CITY OF CANNON BEACH

AGENDA

Meeting: Design Review Board
Date: **Wednesday, February 21, 2024**
Time: 6:00 pm
Location: Council Chambers

- 3) **Continuation of DRB 23-14**, Scott Rochel applicant and property owner, to demolish old garage and rebuild new garage with an Accessory Dwelling Unit (ADU). The property is located at 279 Gulcana Ave (Tax Lot 04501, Map 51031AA) in a Residential Moderate Density (R1) Zone.

Figure 1 – Excerpt of Page 10 of Exhibit D-4

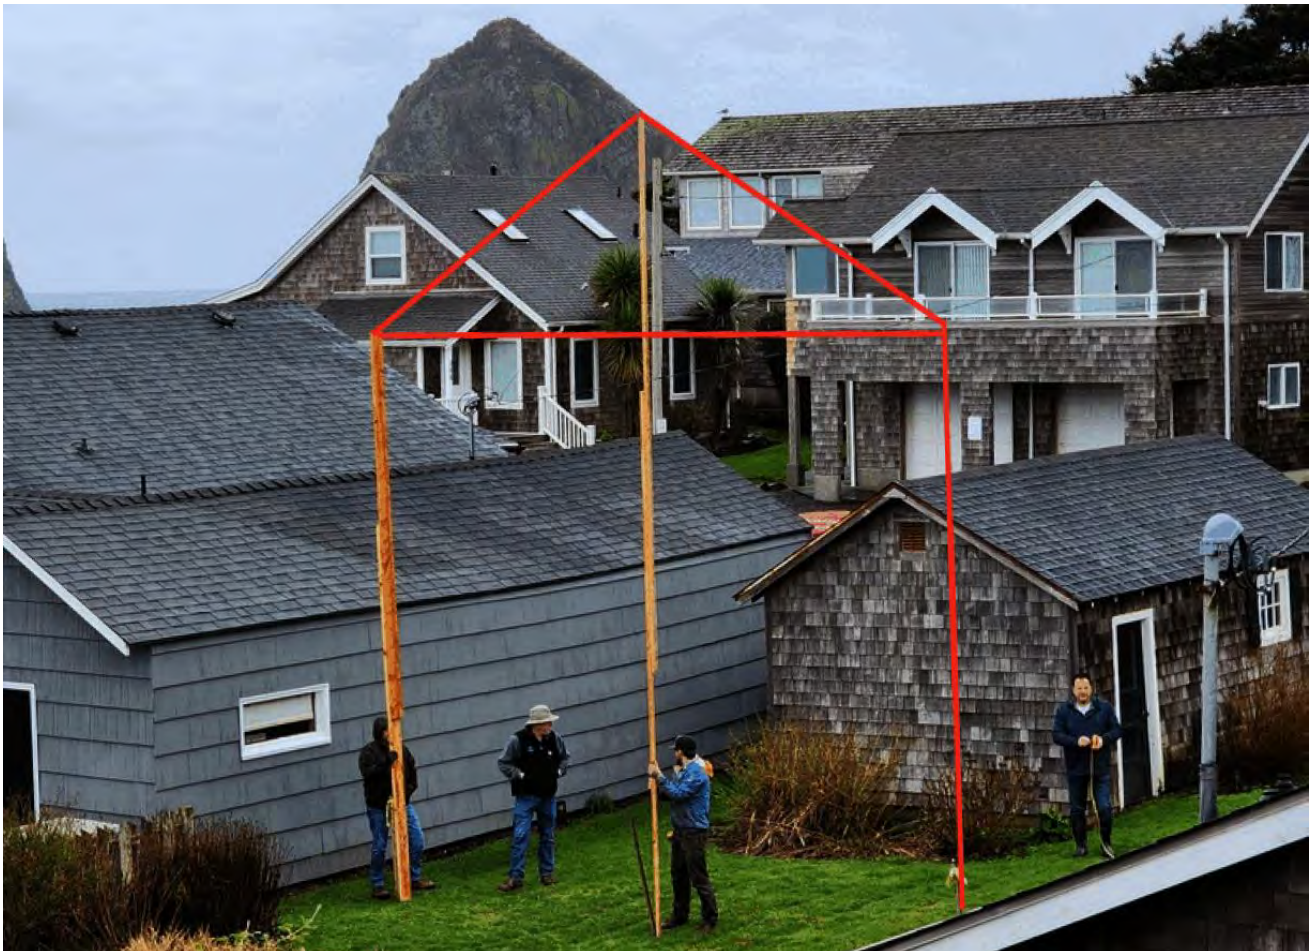
Based on the information in Exhibit D-4 the primary impact to views from Mr. O'Neal's house will be of existing structures at 288 W. Gulcana and 294 Tok Ln with a portion of the eastern flank of Haystack Rock being obscured, this is shown below.

In Exhibit D-4 Mr. O’Neal claims that “views are greatly degraded when you are in a ‘seated position’ looking NW from the same locations as our home” however none of the photos in that exhibit are specified as having been taken from a seated position.
